SUBJECT: Monthly operating repts for Nov 1992 for SSES, units 1 & 2. W/  
921214 ltr.

**SUSQUEHANNA STEAM ELECTRIC STATION**  
**MONTHLY OPERATING REPORTS**  
**PLA-3889 FILE R41-2A**

PENNSYLVANIA POWER & LIGHT COMPANY  
SUSQUEHANNA STEAM ELECTRIC STATION  
OFFSITE DOSE CALCULATION MANUAL

## SUMMARY OF ODCM CHANGES

FIGURE 5  
 ENVIRONMENTAL MONITORING LOCATIONS  
 WITHIN ONE MILE OF THE SSES

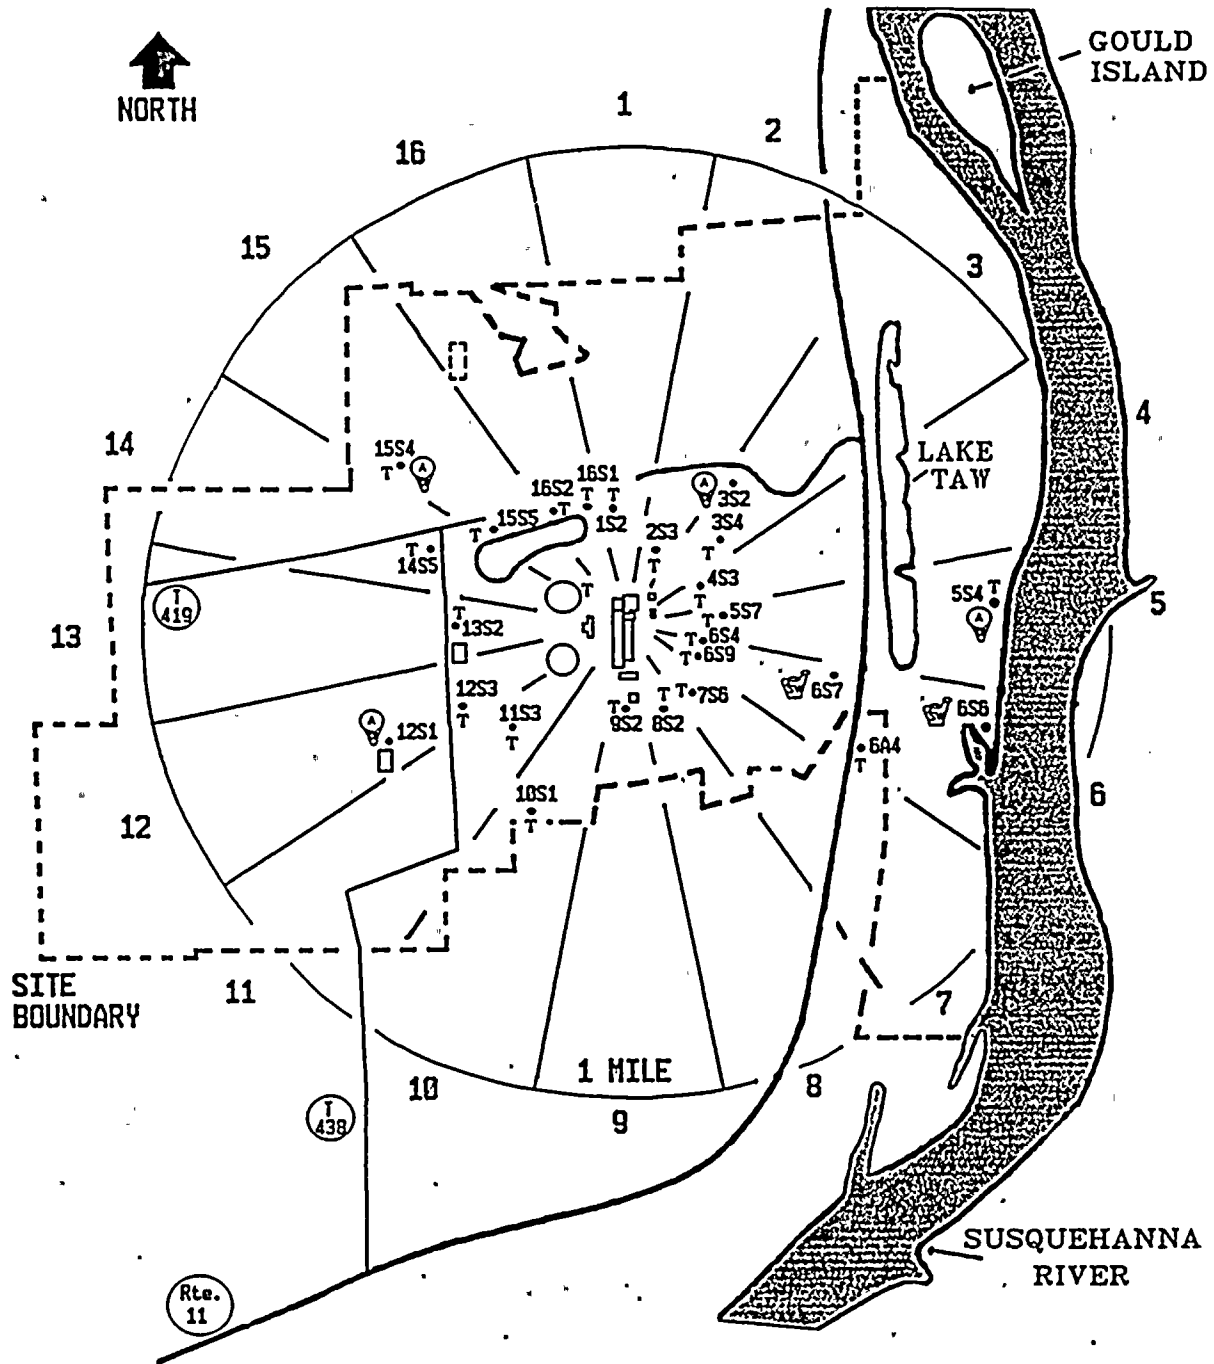
4. The position of TLD monitoring station 13S2 in Figure 5 has been changed to reflect correctly its location east of the road. No change to the actual monitoring location has been made. Figure 5 has also been changed to reflect the site boundary placement to the northeast (Sector 3: Gould Island) and to the south (Sector 7) more accurately.
